**ADDENDUM NUMBER 2**

**Thursday, January 23, 2025**

**PROJECT: BRISCOE PARK  
COMMUNITY CENTER, GA  
GMC PROJECT NO. AATL2300037**

**G8 PATIO PILASTERS**  
SCALE: 3/4" = 1'-0"

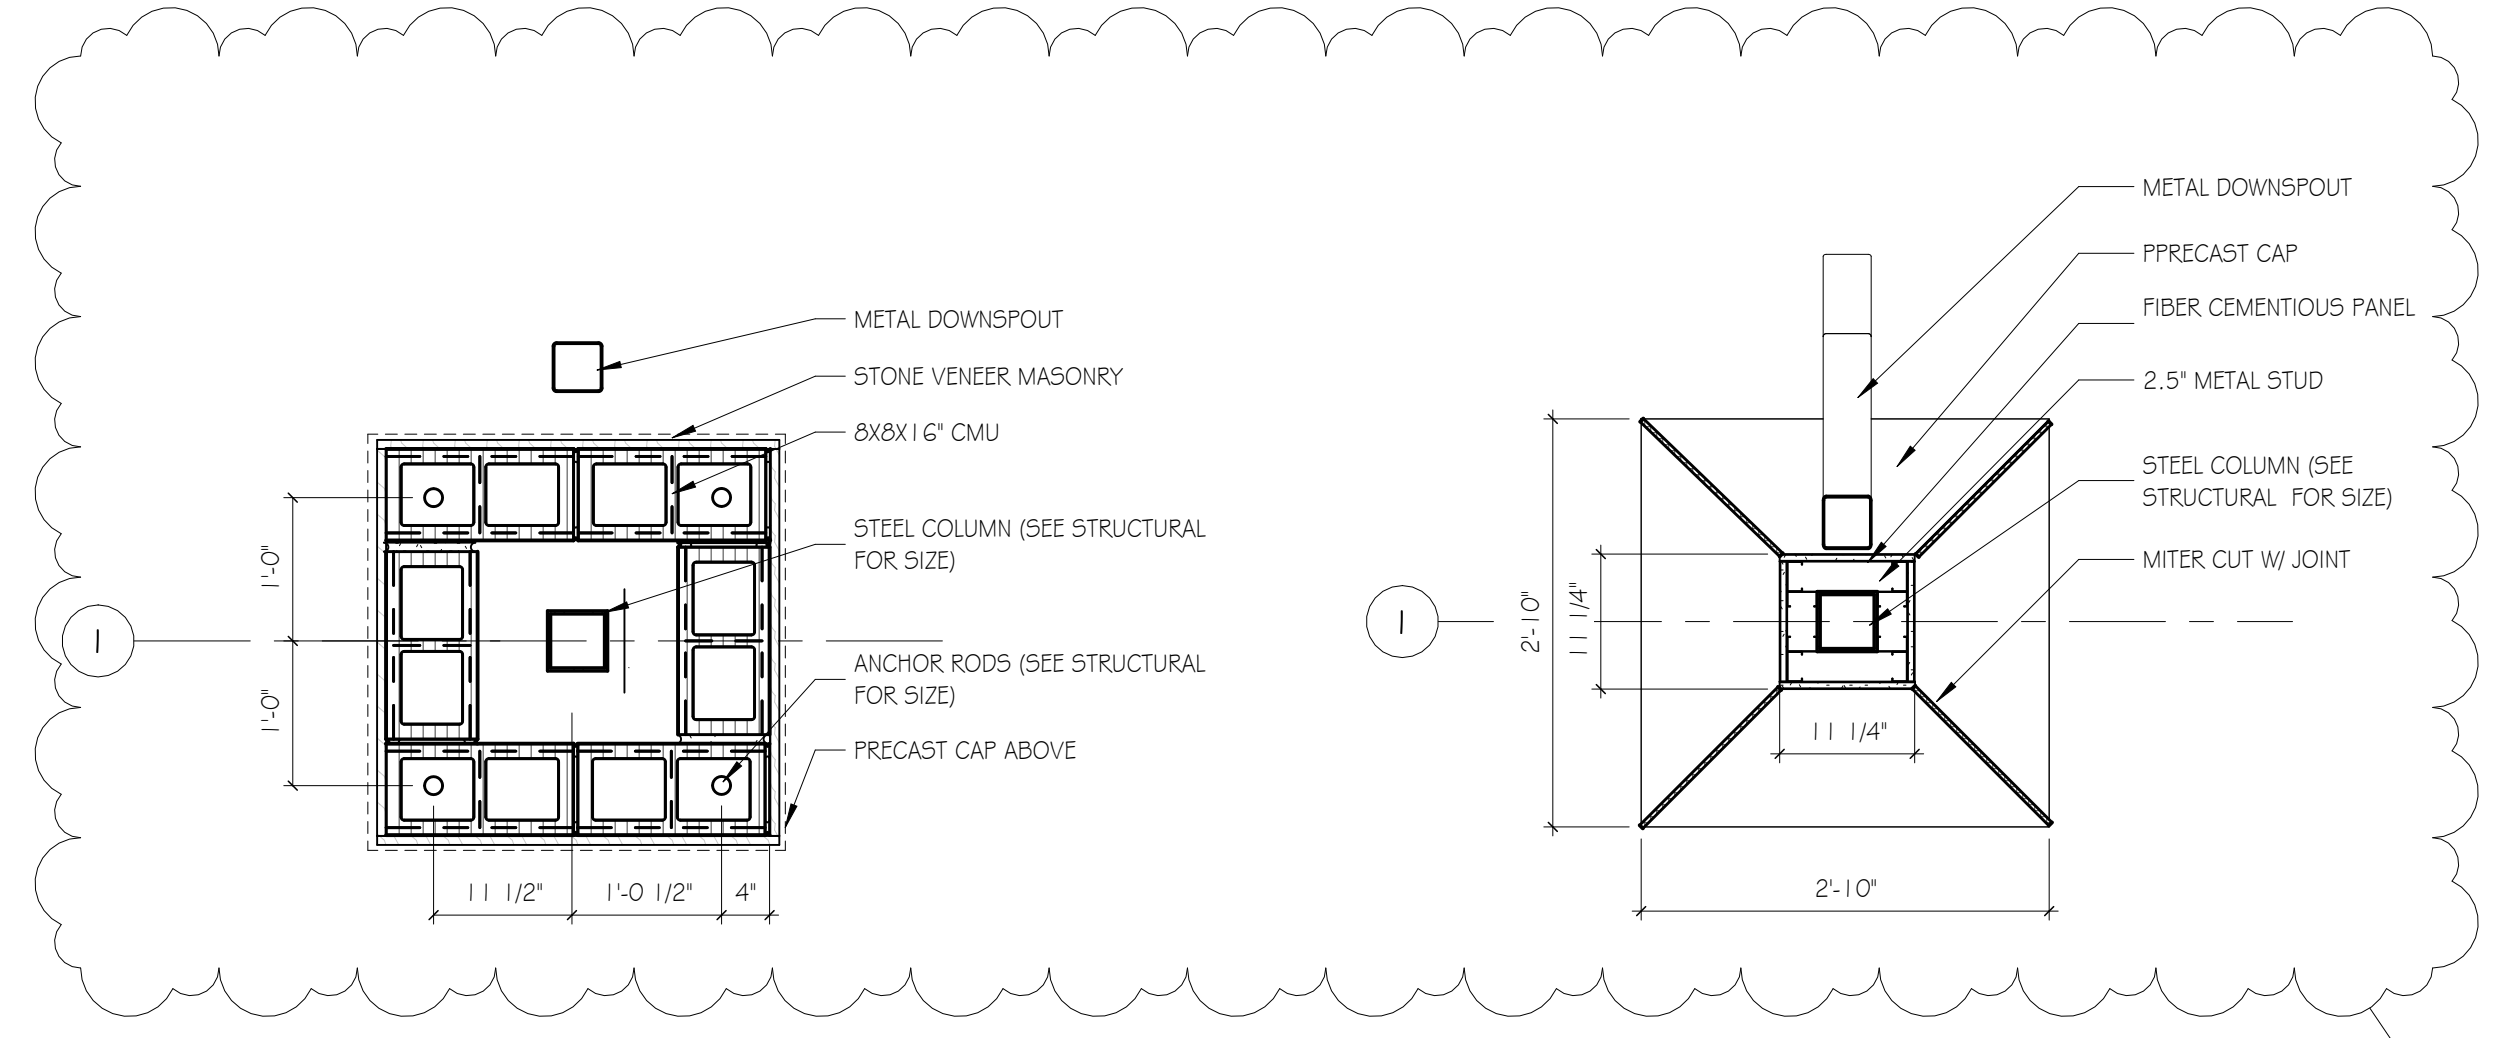
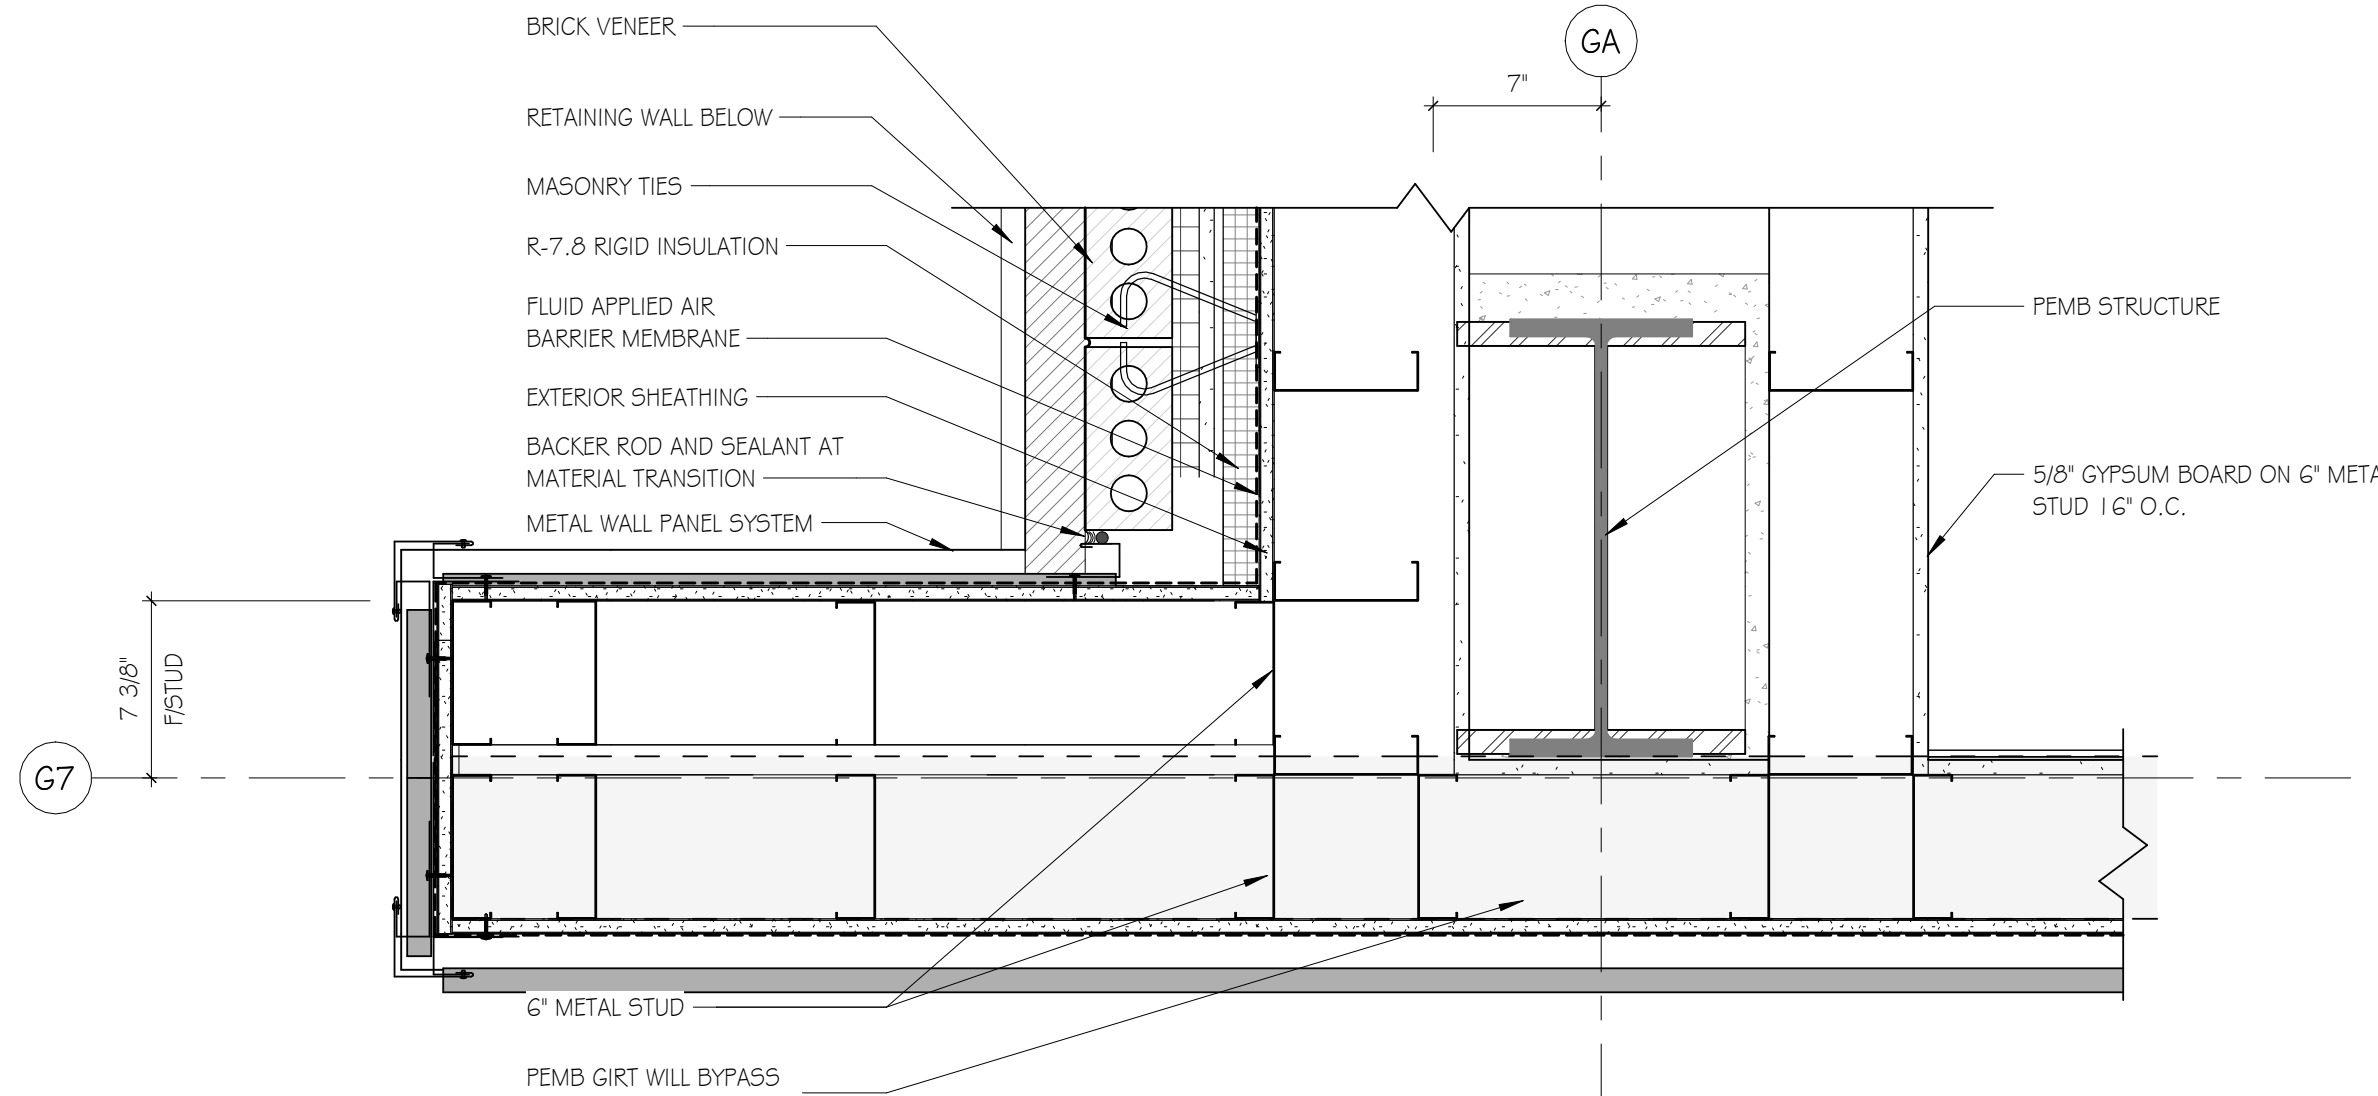
- I. S3.13 – CONCRETE WALL DETAILS
  - 1. Updated to show interior retaining wall elevation
- J. A1.11- ENLARGED PLANS
  - 1. Updated equipment types
- K. A1.21 – PLAN DETAILS
  - 1. Updated wrapped patio pilaster details
- L. A2.01- RCP LEVEL 1
  - 1. Showing roller shade locations and exposed ceiling areas
- M. A2.02- RCP LEVEL 2
  - 1. Showing roller shade locations and exposed ceiling areas
- N. A4.01- EXTERIOR ELEVATION
  - 1. Updated sunshade placements and signage
- O. A4.02- EXTERIOR ELEVATION
  - 1. Updated sunshade placements.
- P. A5.13 – WALL SECTIONS
  - 1. Section of Exterior Patio pilaster.
- Q. A7.01- INTERIOR ELEVATIONS TOILETS
  - 1. Updated type of toilets and finishes
- R. A8.01- FINISH LEGEND AND SCHEDULE
  - 1. Updated paint color.

**EXTERIOR ELEVATIONS**  
**A4.01**  
sheet of

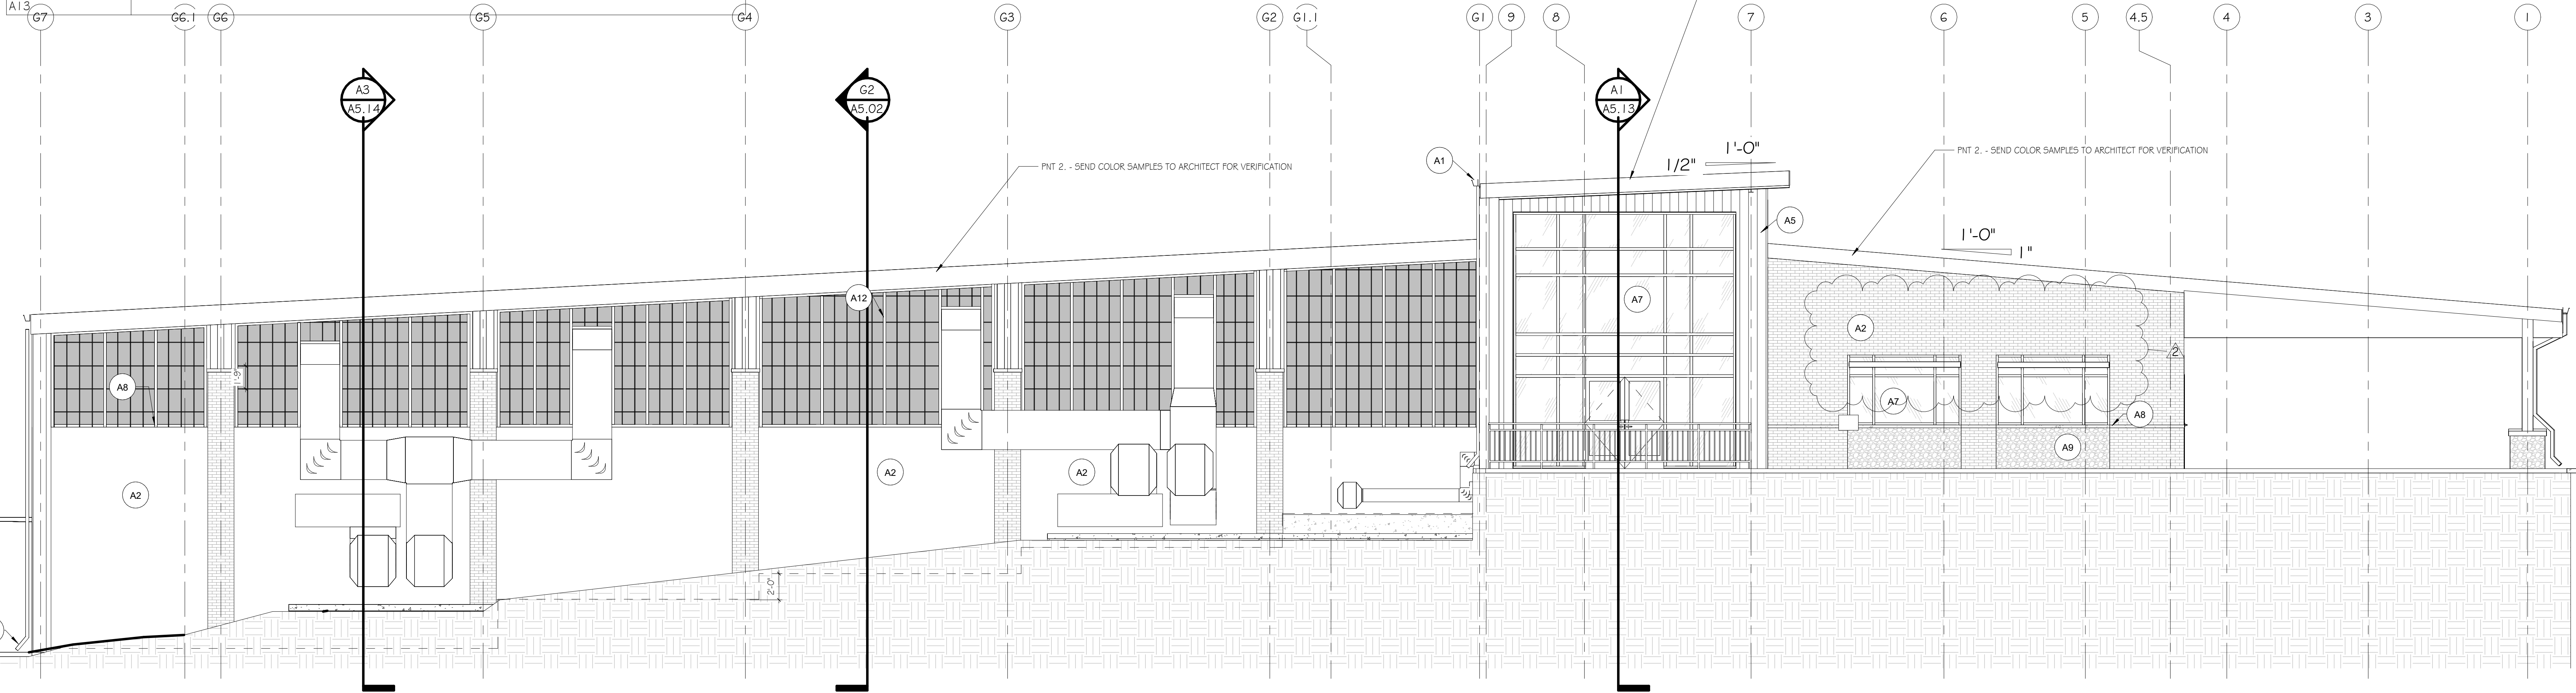
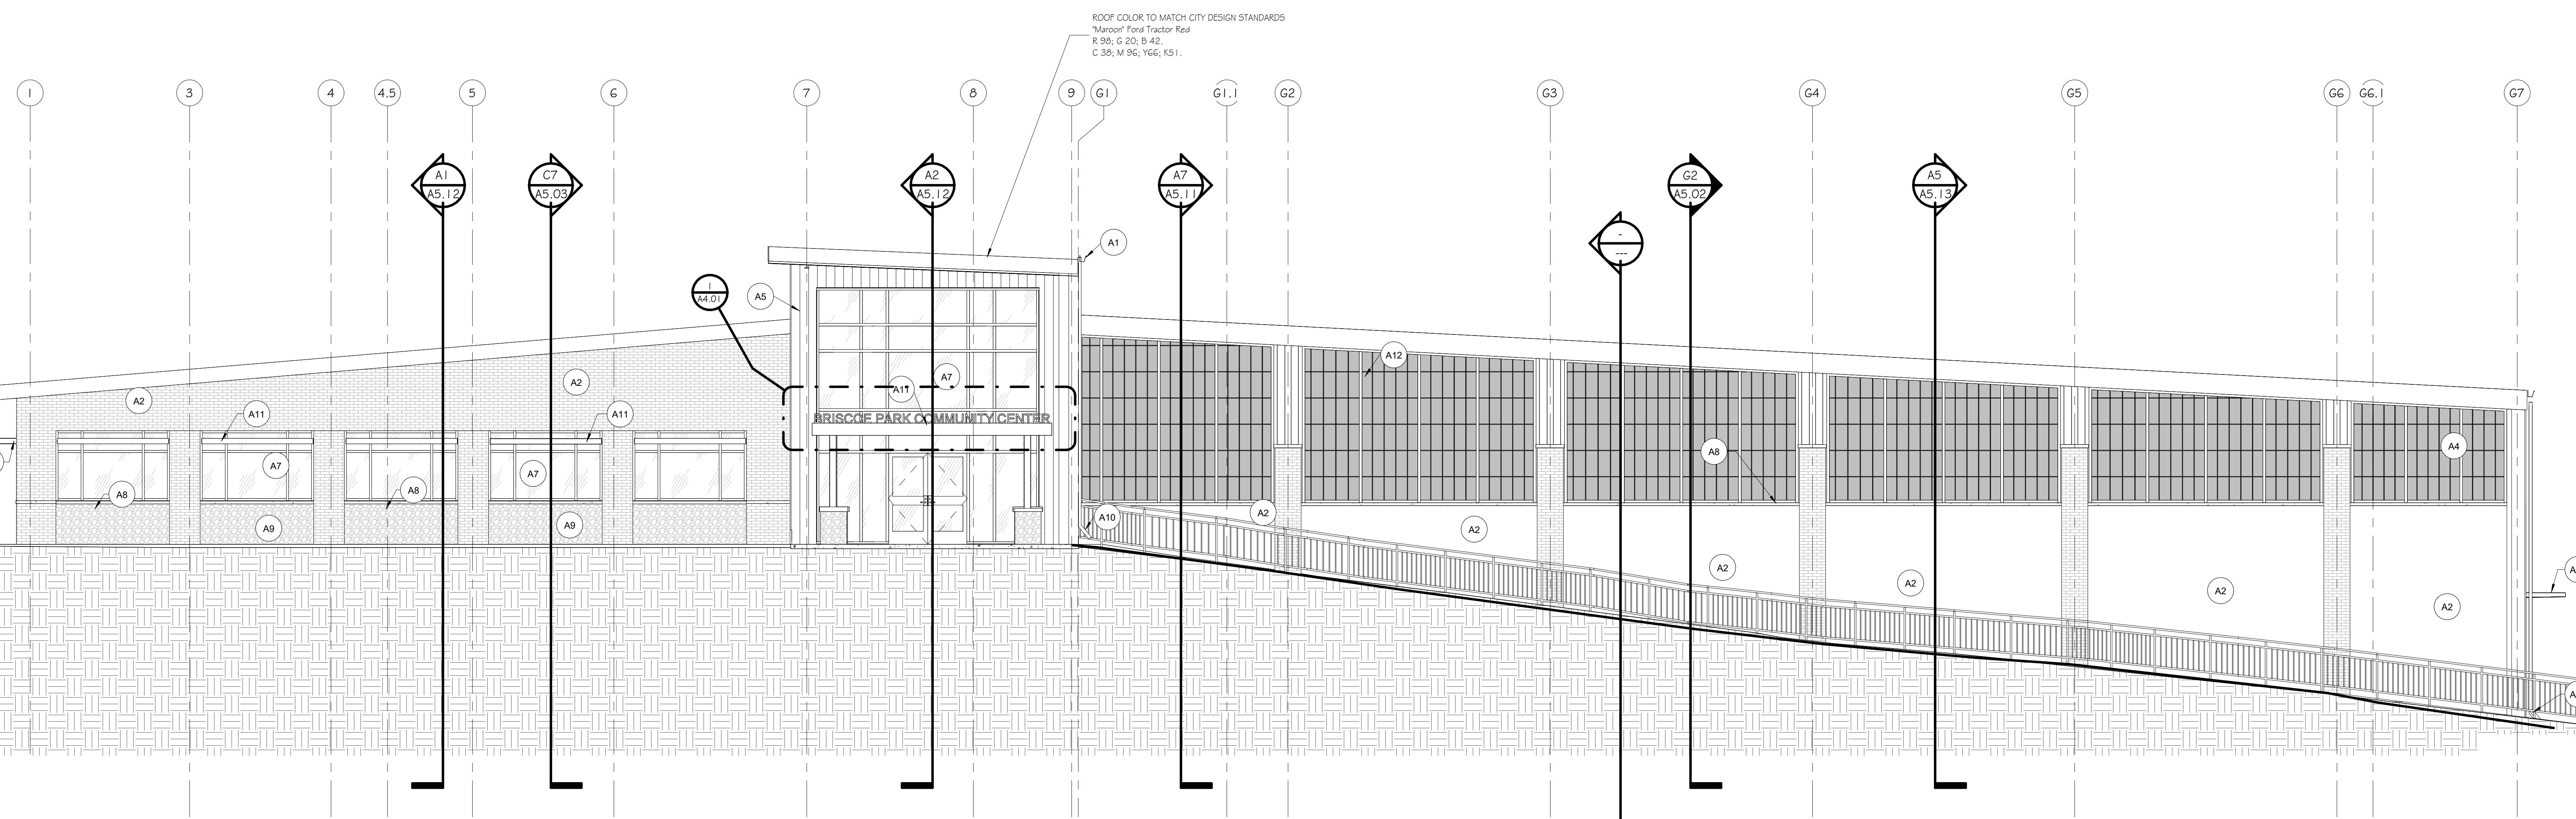
A1 on sheet A4.01 indicates A7-Storefront as Scheduled on what seems to be the material shown for standing seam metal roof between column lines C & D. Please confirm this area is A3 - Standing Seam Metal Roof.	Correct that is supposed to be A3 Tag.
Civil	Please confirm detail G4 on sheet C-904 is to be used for the patch and repair of the new sewer line connection on EX SSMH at Marigold Rd.	Confirmed, this is to be per the Gwinnett County Detail on Sheet C-904
<b>NEW COMMENTS</b>	<b>1/17/2025 EOD</b>	
STRUC.	S1.01 Can wall elevations be provided showing top of wall elevations for the concrete retaining walls as detailed on 1&2/S3.02 for slopes?	Attached with addendum #2
ARCH/SPECS	Please provide a copy of the Geotechnical report as referenced in the specifications.	ATTACHED WITH ADDENDUM #1
ARCH/SPECS	A4.01- A4.02 Please provide specification for Granite Stone veneer (A9) on Elevation Keynote Legend	Design intent is using Country LedgeStone, wheaton.
